**City of Surrey
PLANNING & DEVELOPMENT REPORT**

Application No.: 7920-0216-00

Planning Report Date: June 13, 2022

to permit the development of Phase 2 of a mixed-use project, consisting of one 53-storey mixed-use tower and one 2-storey standalone commercial building.

PHASE 2 - SITE PLAN

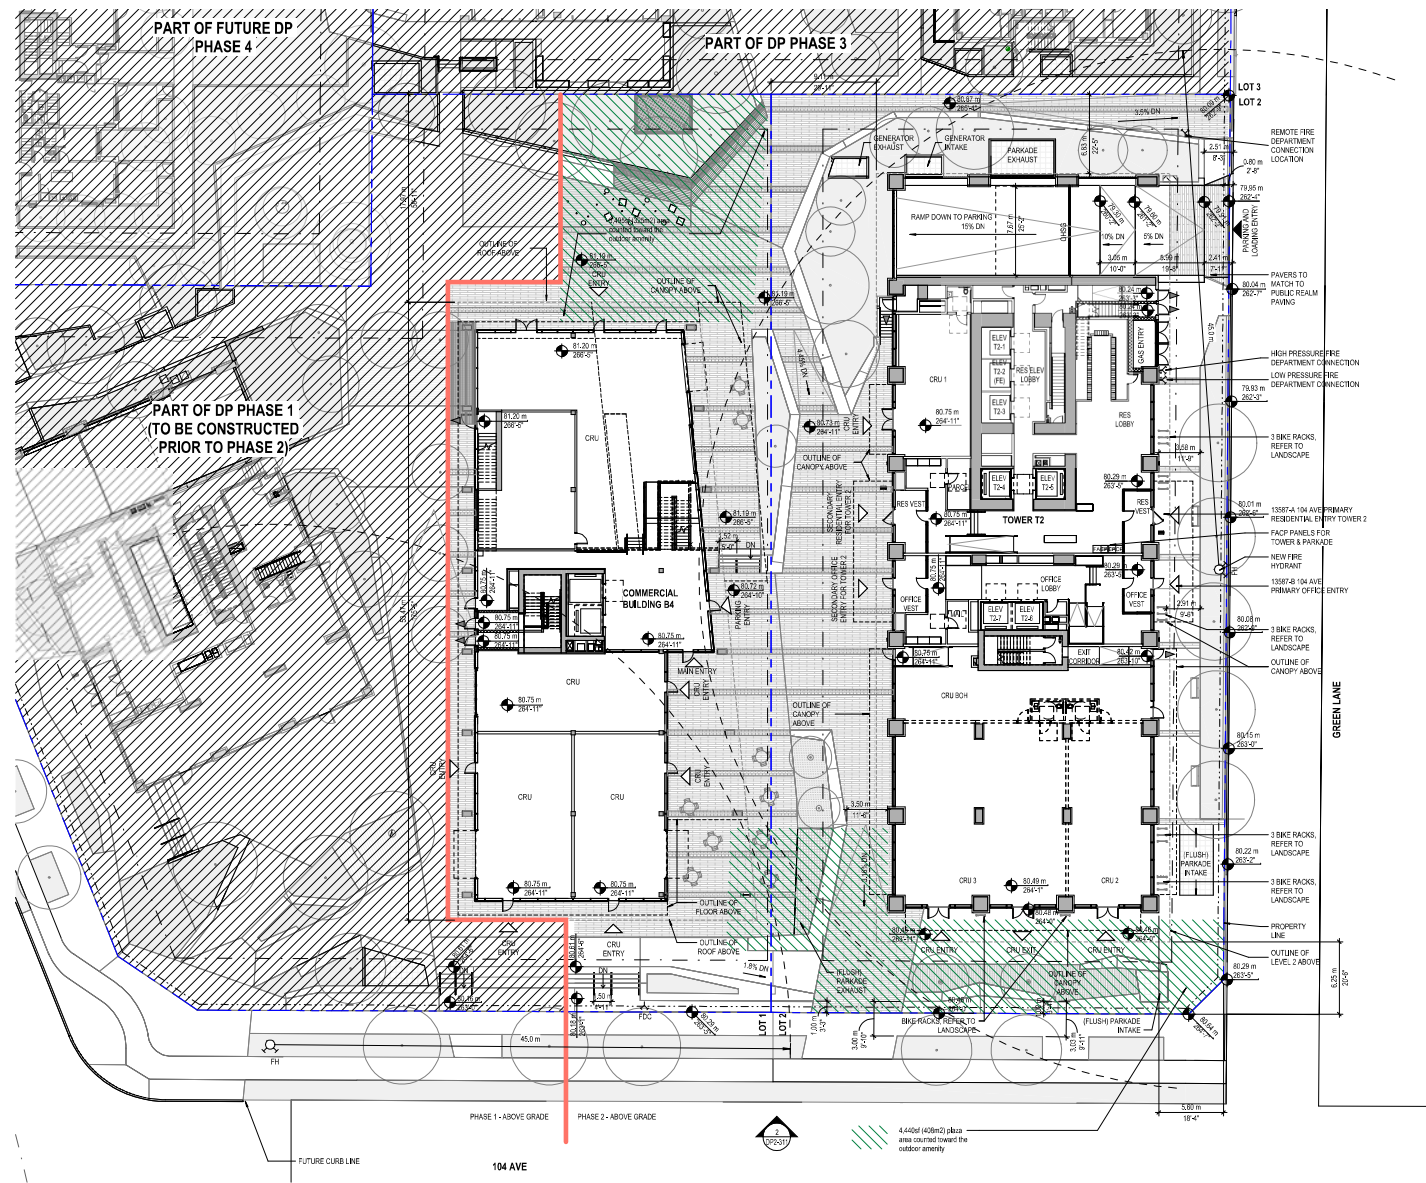
- Consider addressing the pinch points in outdoor circulation, especially at the wood seating area in the center of the site.
(This area was revised with increase public space during site wide resubmission – please refer to DP2-004.)

- Recommend a larger outdoor gathering space/room at the centre of the site.
(This area was revised with increase public space during site wide resubmission – please refer to DP2-004.)

B4 - ELEVATIONS

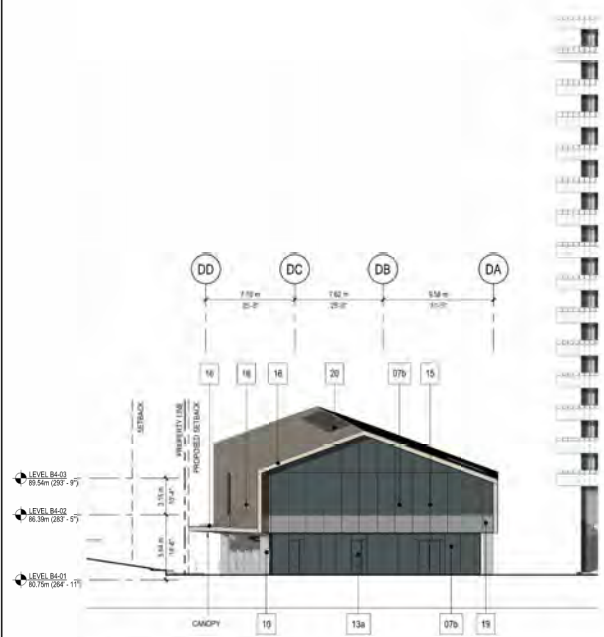
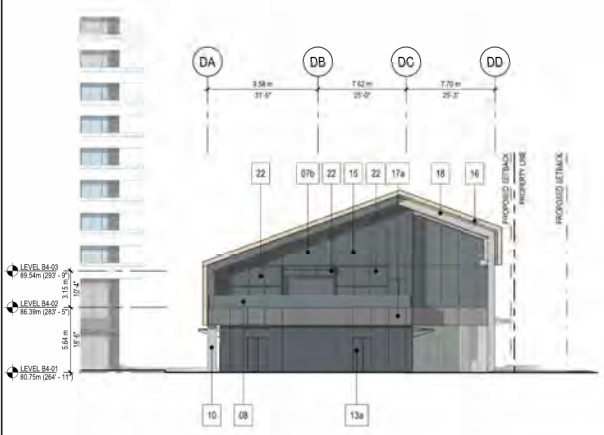
- Consider increasing the amount of glazing at the commercial building.
(Both barn buildings B4 and B5 are fully glazed north and south, additional skylight added along the length on the roof. We have also revised the structural spacing at grade to eliminate every second columns therefore increasing retail visibility. Large fold-up doors will allow for food & beverage type retails to spill out on the mews.)
